NUREG-0847
Supplement 24

Safety Evaluation Report

Related to the Operation of
Watts Bar Nuclear Plant, Unit 2

Tennessee Valley Authority

Figure 15.1-1 Illustration of overtemperature and overpower delta-T protection

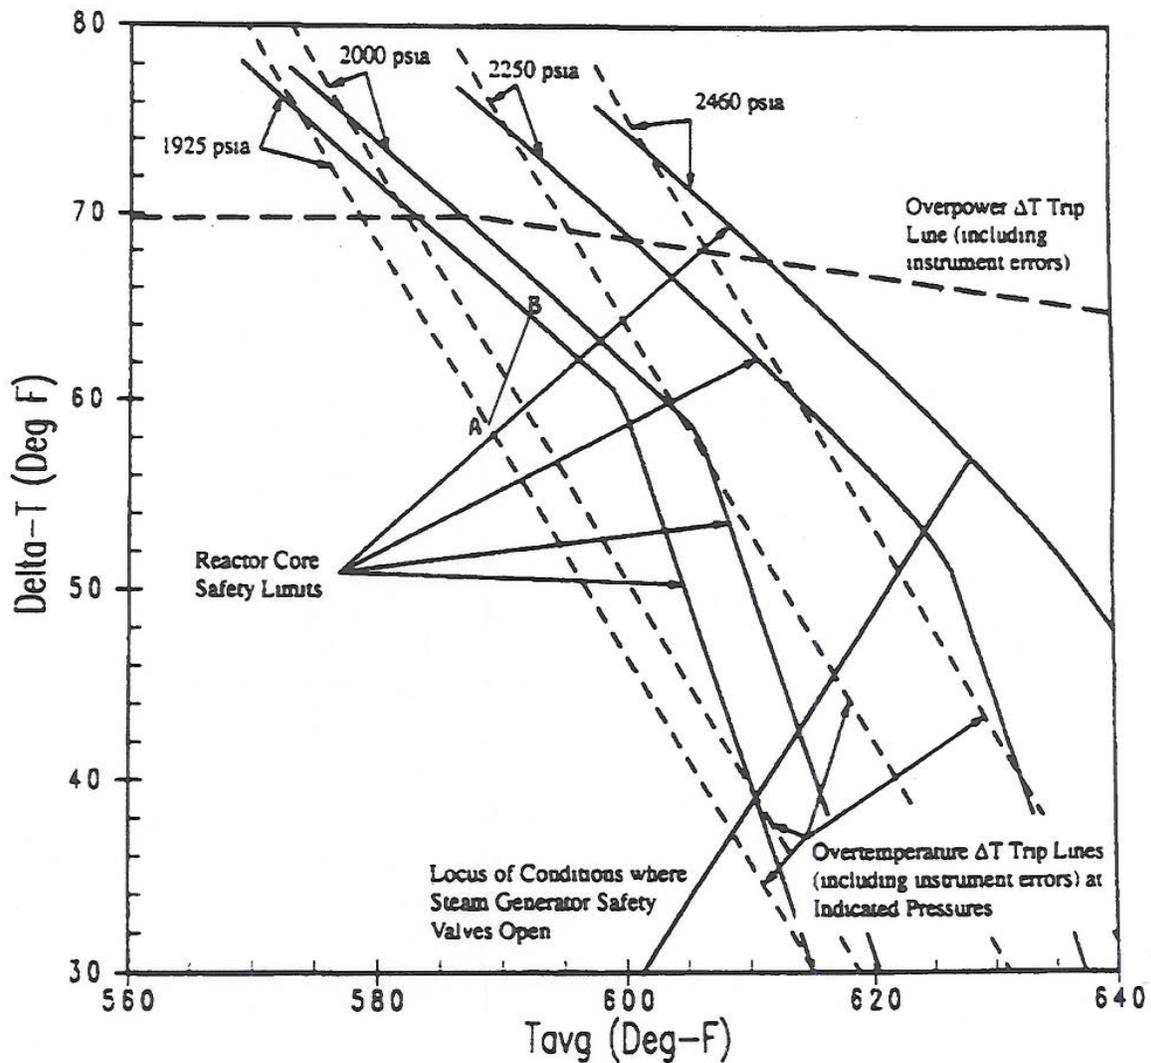
TVA compared the RCS temperature, pressurizer pressure, and core power level (indicated by ΔT) for each of the various initial conditions, or statepoints, to the RCS temperature, pressurizer pressure, and core power level values that would produce the DNBR SAL. Figure 15.1-1, "Illustration of Overtemperature and Overpower Delta-T Protection," in the FSAR for WBN Unit 2 and reproduced below depicts the locus of points, on a plot of ΔT versus average T (degrees Celsius (C) (Fahrenheit (F))), at which the DNBR is at the DNBR SAL. This figure also depicts plots of the calculated overpower and overtemperature ΔT reactor trip setpoints that are intended to trip the reactor before conditions can reach those corresponding to the DNBR SAL.

Using FSAR Figure 15.1-1, the NRC staff located the nominal operating condition ($T_{avg}=588.2$ degrees F and $\Delta T=58.4$ degrees F) and designated it as point A. The nominal operating condition lies well below and to the left of the DNBR SAL and overtemperature ΔT lines that correspond to operation at nominal pressure (2,250 pounds-force per square inch (psia)). Point A represents the plant operating conditions that would exist before the occurrence of a 10-percent step-load increase. A second point (point B), representing operation at 110-percent power (i.e., the endpoint of a 10-percent step-load increase) was marked on the figure at $T_{avg}=591.1$ degrees F and $\Delta T=64.2$ degrees F. The line connecting the two points maps the path, from point A to point B, of an excessive load increase incident relative to the DNBR SAL. It extends upward and to the right, toward the DNBR SAL and overtemperature ΔT lines that correspond to operation at nominal pressure.

Therefore, the NRC staff's exercise, employing FSAR Figure 15.1-1, verifies TVA's conclusion that the DNBR SAL is not violated in the event of an excessive load increase incident. The nature of the event (a cooldown and possible depressurization) indicates that RCPB integrity is not challenged. Although a reactor trip might be required, it could not be prevented, delayed, or otherwise impeded by a single failure.
